Product Equality Declaration

We, Lenovo (Shanghai) Electronics Technology Co., Ltd. declare on our sole responsibility for the product of **501LV,502LV** as below:

The differences between 501LV,502LV and previous as below:

Diff in Ant Pattern

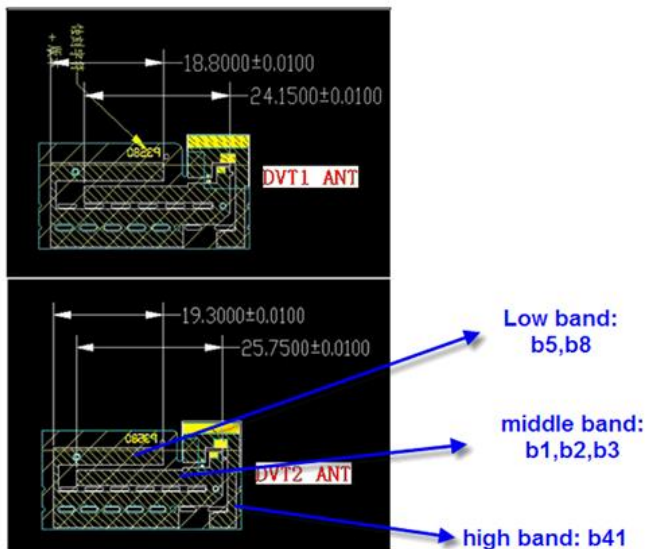
- ◆ Enable Tablet receiver by software
- ◆ Adapter change from Soft Bank ZTDAC 1(1A), ZTDAD1(1.8A) to C-P62(1.5A)
- ◆ WWAN Antenna changed as below:
 - (1). DVT2 Antenna Pattern is longer than DVT1, but the max Gain value keep same
 - (2). Antenna area is bigger
